RUSSELL VALE COLLIERY STAGE 1 EXTRACTION PLAN

Reasons for Approval

3. EXTRACTION PLAN APPLICATION

Figure 1: Stage 1 Extraction Plan Area and Mine Plan

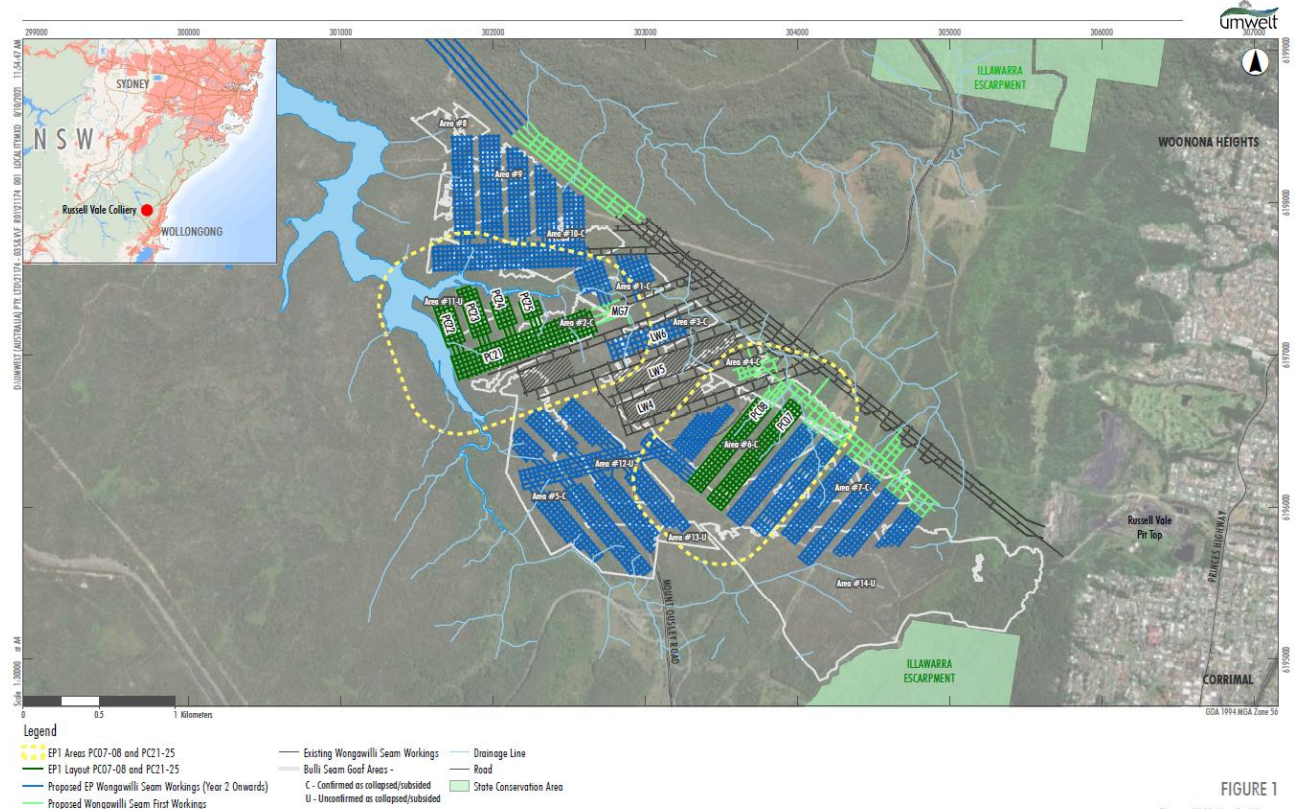
- On 8 October 2021, Wollongong Coal submitted an application for approval of an Extraction Plan in accordance with condition C10 of MP 09_0013. The plan covered Stage 1 mining, comprising bord and pillar extraction of seven panels, PC07, PC08 and PC21 to PC25 (refer to **Figure 1**).
- The plan proposes pillar dimensions of 22.5m by 24.5m and 24.5m by 24.5m. All pillars have a high factor of safety, equivalent to a risk of failure of less than 1 in 1,000,000. SCT Operations

1. This approval is limited to the secondary extraction of PC21. Approval of secondary extraction in subsequent panels would be subject to demonstrating to the satisfaction of the Secretary that conditions 2 to 5 have been met, and any further agency advice is adequately addressed.

2. Prior to second workings commencing in PC22, PC23, PC24, PC25, PC07 or PC08, the Applicant must demonstrate to the satisfaction of the Planning Secretary that subsidence movements from the extraction of PC21 are within predicted levels and that the subsidence impact performance measures outlined in Table 6 and Table 7 of MP 09_0013 are expected to be met across the Stage 1 Extraction Plan area.
